Airworthiness Directive: #112

Subject: Taildragger Cages

Models Effected: All S-6 Taildraggers

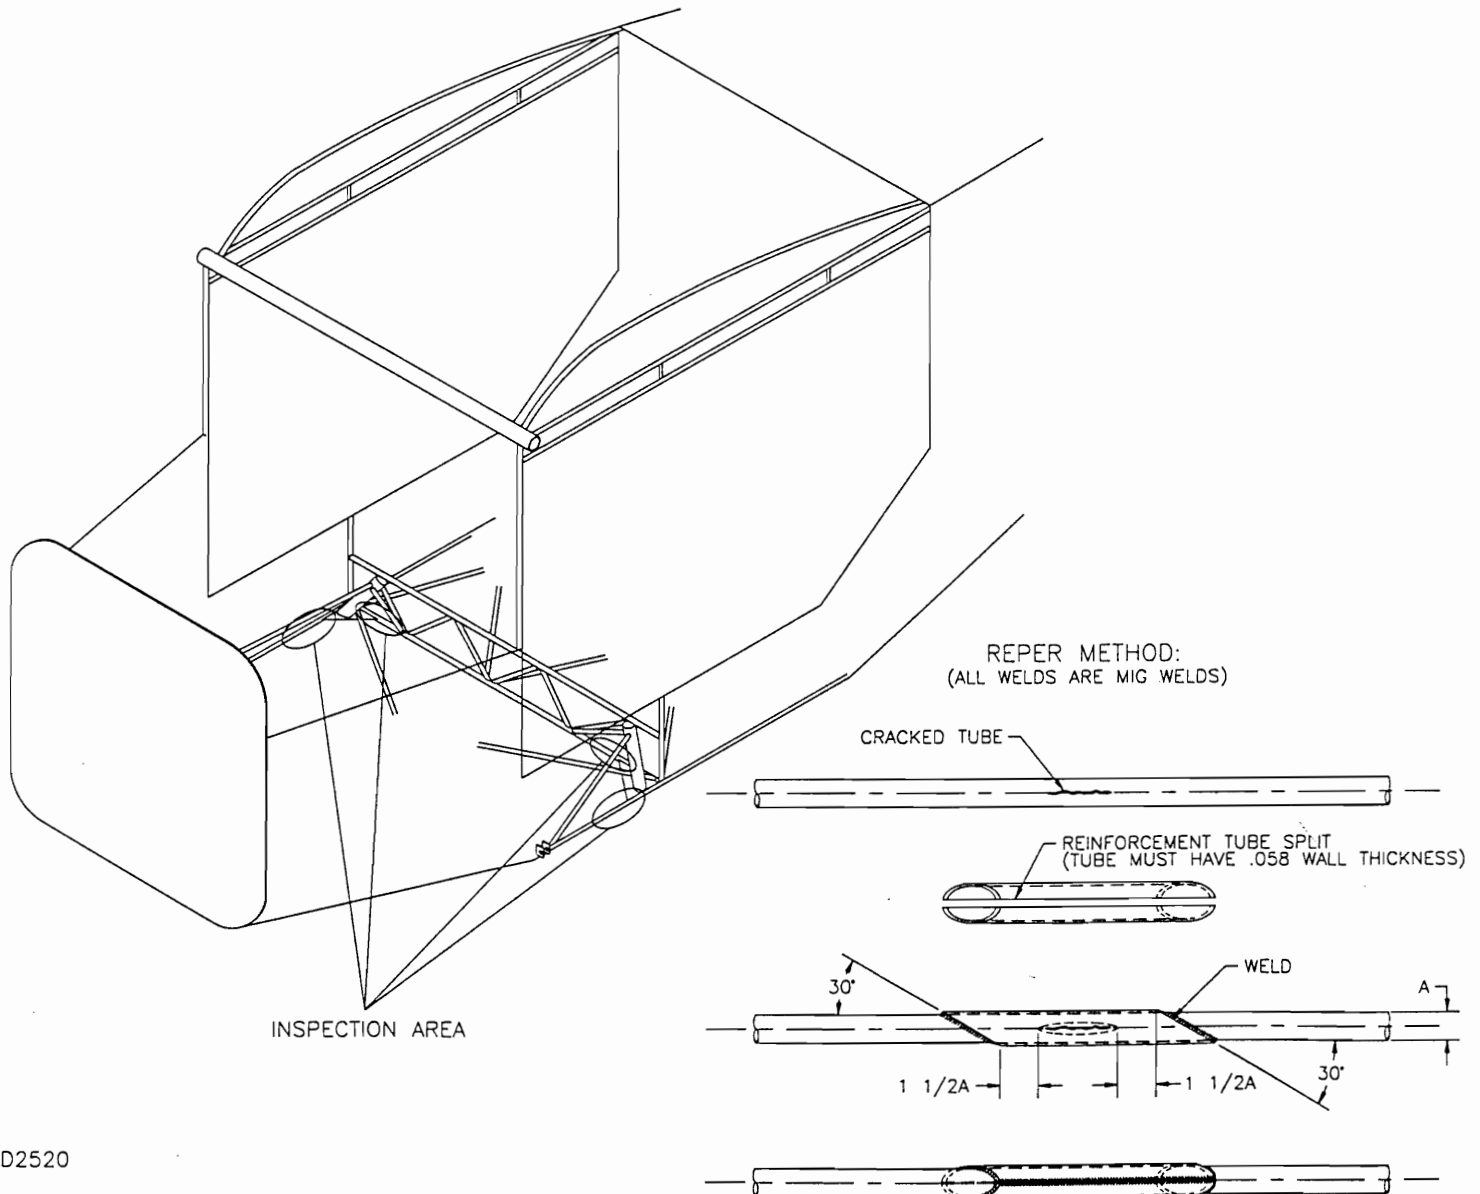
Stress cracking was reported on one S-6 taildragger cage in the area shown below. All S-6ES, S-6S and S-6XL taildragger models must be inspected to determine if this problem exists.

If no cracks are found, than a periodic inspection every 250 hours must be performed. If inspection reveals cracks, repair as shown below.
